Date: April 6, 2023

Subject: Widefield Parks and Recreation – Recreation Center – Pond Outlet Structure

POND DETAILS

C7.5

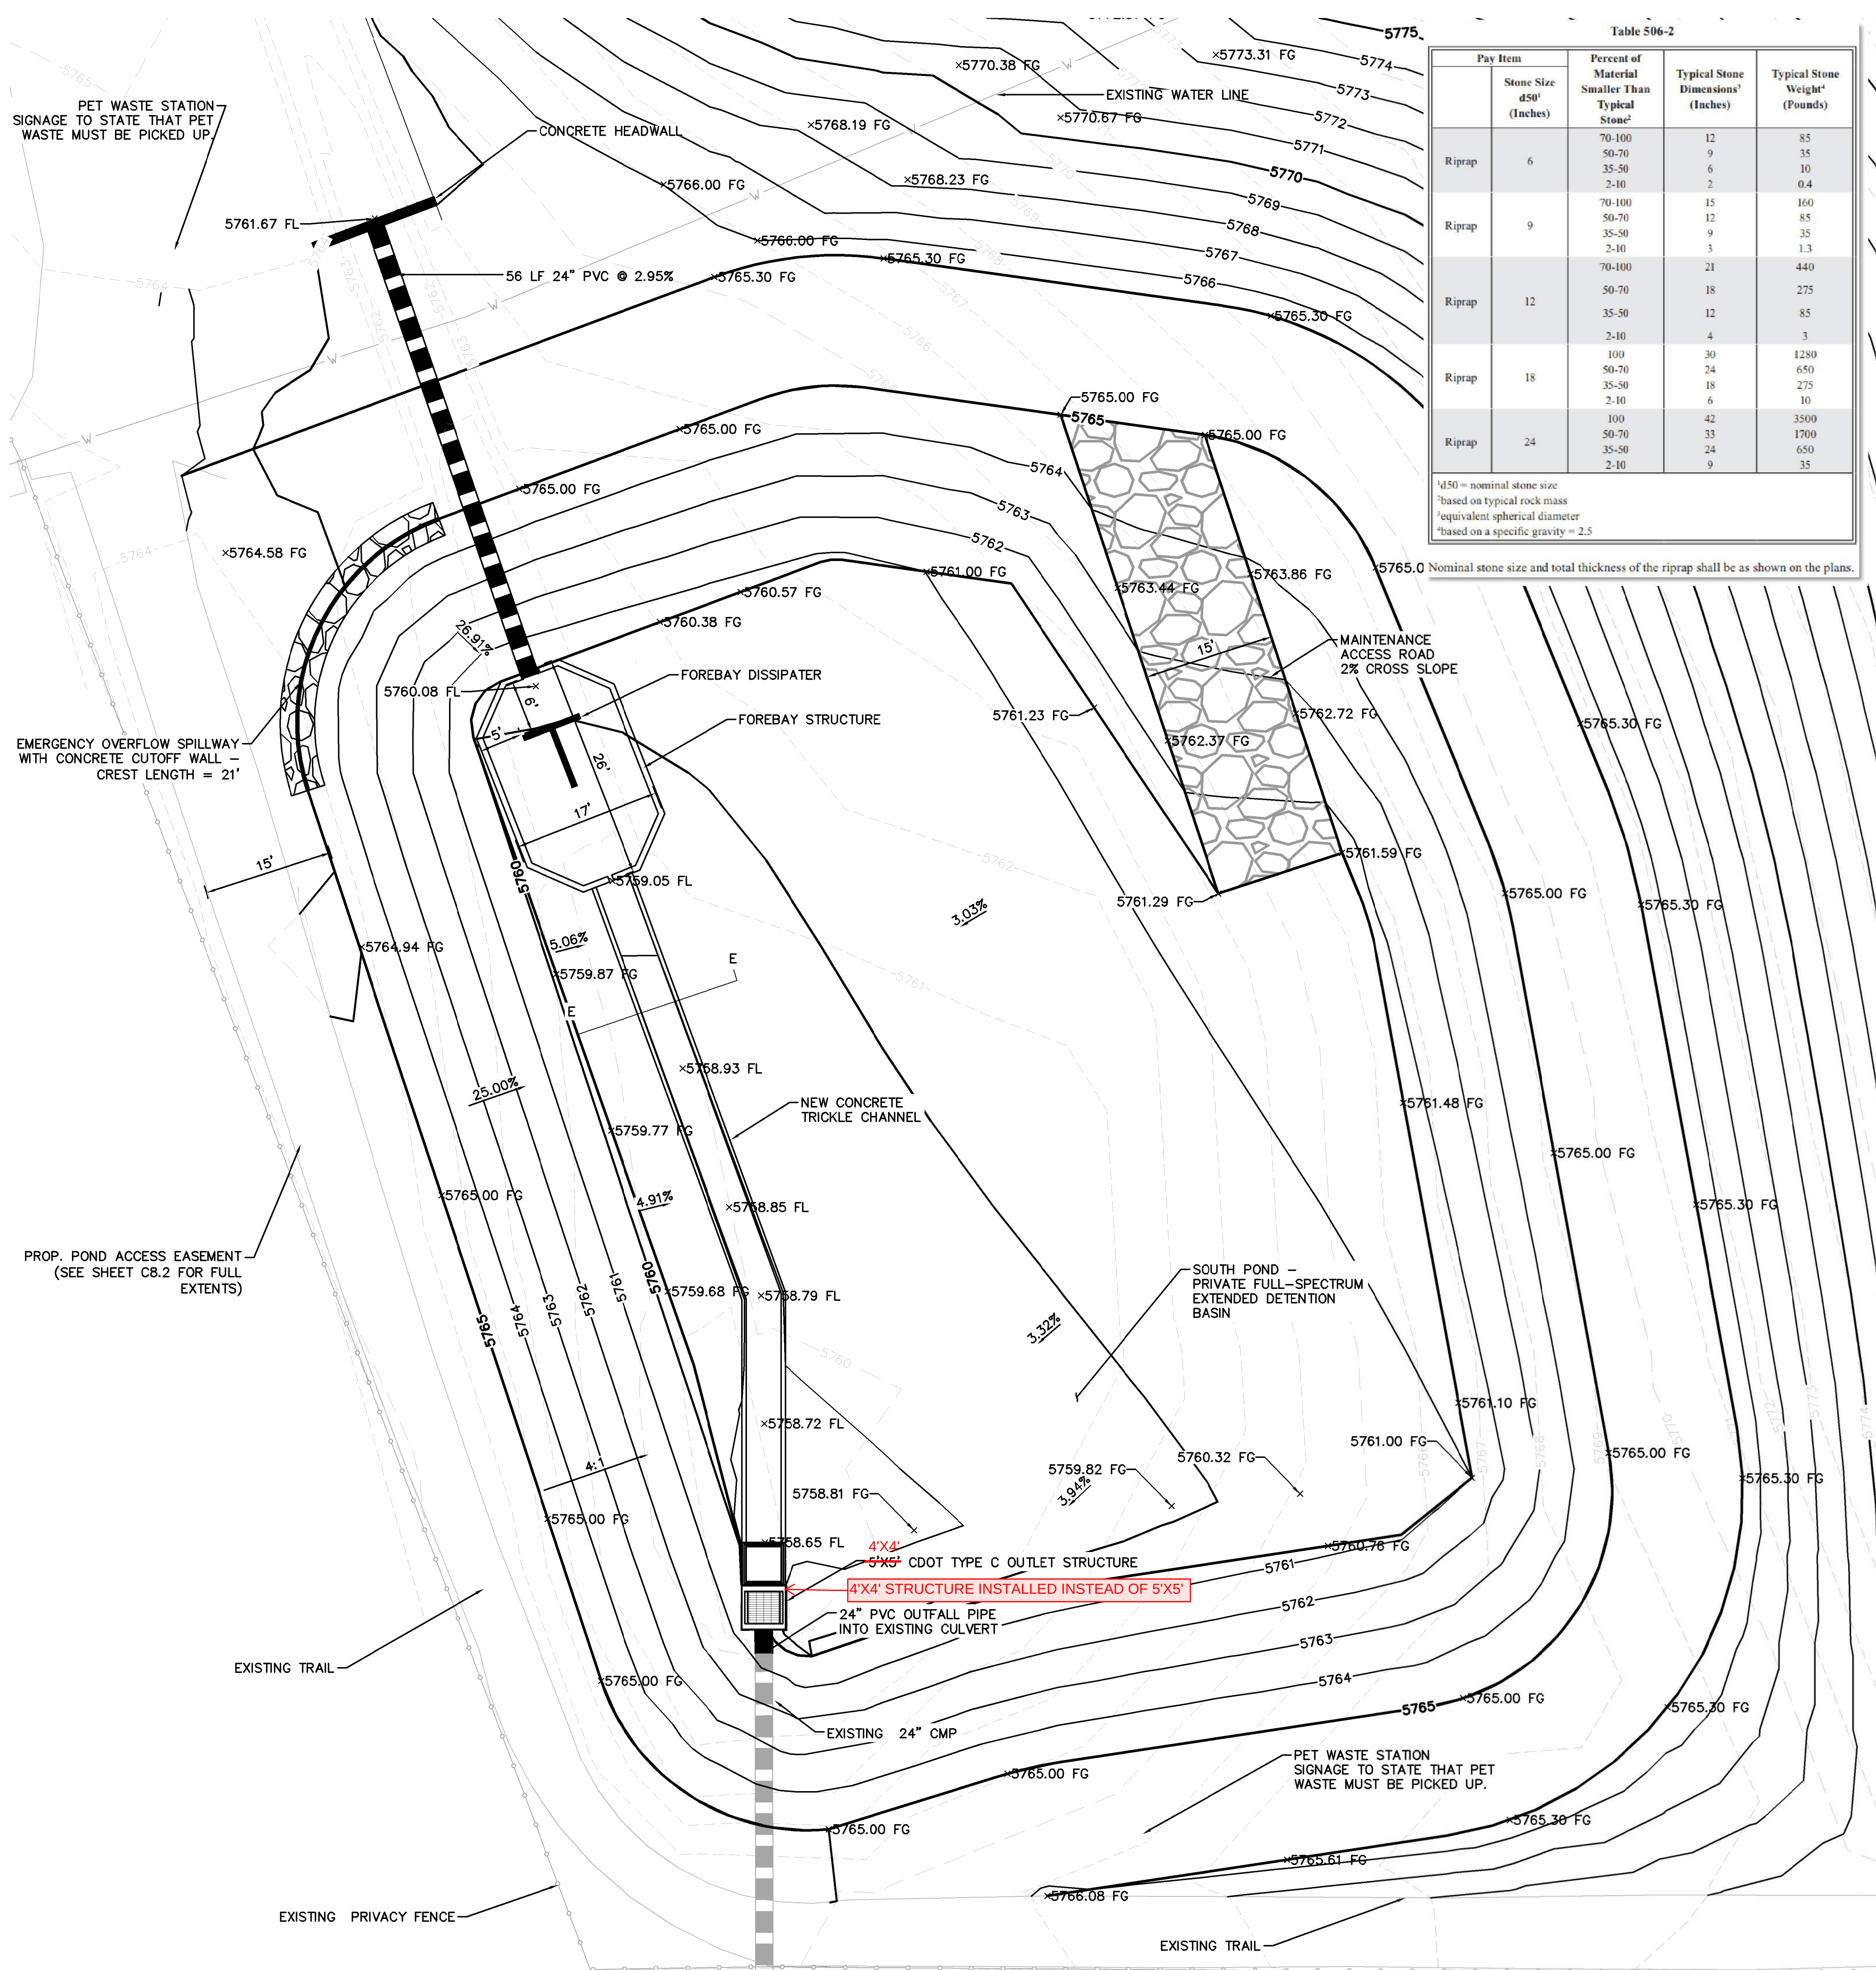
Based upon an email received by Kimley-Horn from Lisa Gish dated April 4, 2023 4:09PM, it is understood the proposed outlet structure in the extended detention basin at the subject site has been constructed differently than the approved plans dated 2/28/23. The approved plans call for a 5'x5' Type C CDOT structure with 4:1 sideslope/grate. Based upon the referenced email from the County, it is understood the structure was installed at 4'x4' and was installed with a flat top instead of the 4:1 sloping grate.

Attached is a markup of the approved pond plans showing the as constructed condition based upon the information above. Kimley-Horn redesigned the outlet structure using this information and the MHFD analysis has been included in this memo, following the plan markup.

Kimley-Horn proposes lowering the restrictor plate on the outlet pipe 6" for a total of 12" of clearance as noted. This will maintain the appropriate pre-development vs. post development flow ratios and drain times to be in compliance with the approved final drainage report for the project.

AS CONSTRUCTED NOTES PER EMAIL DATED 4/4/23
4:09PM FROM LISA GISH, ENGINEERING INSPECTOR I,
DEPARTMENT OF PUBLIC WORKS, EL PASO COUNTY

Based upon the information above and analysis performed herein and the adjustment to the restrictor plate, the change in size and slope of the outlet structure is acceptable to the engineer of record.

PROPOSED MODIFICATION BY KIMLEY-HORN
ERIC GUNDERSON, PE
4/6/23
